Maxtor Corporation
500 McCarthy Boulevard
Milpitas, CA 95035 USA

To: Serial Attached SCSI Protocol Working Group
From: Mark Evans
Phone: 408-894-5310
Email: mark_evans@maxtor.com
Date: 08-15 July 2002

Subject: SAS [SSP initiator](#) transport layer state machines ~~for SSP~~

Figure 1. SSP initiator device state machine

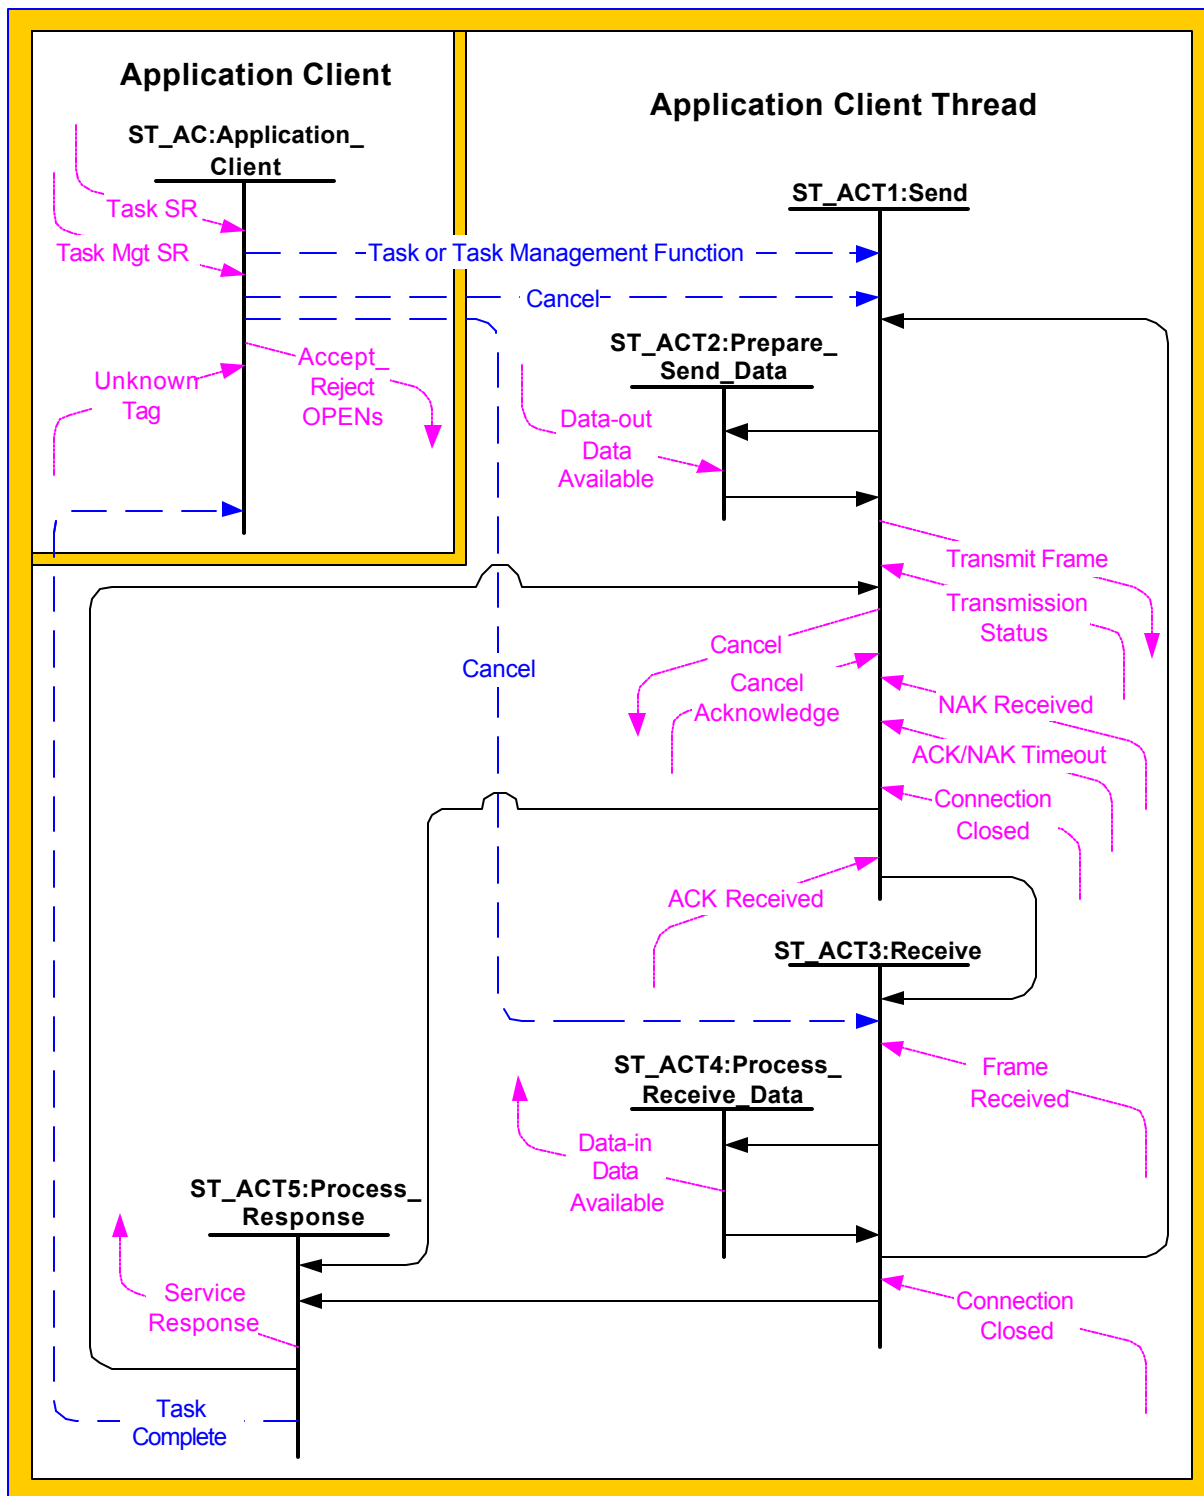
In this revision, only the [SCSI SAS](#) initiator device elements are included. This proposal has been revised based on discussion at the SAS working group meetings, June 24 through 26, 2002. In addition, the “application client” state machine has been renamed “application client”, and the “application client” state machine has been renamed “application client thread” to conform to a proposed letter ballot resolution for SAM-2. The [SCSI SAS](#) target device elements are under construction and will be included in a subsequent revision of this proposal.

Figure 1 describes the SSP initiator device state machine.
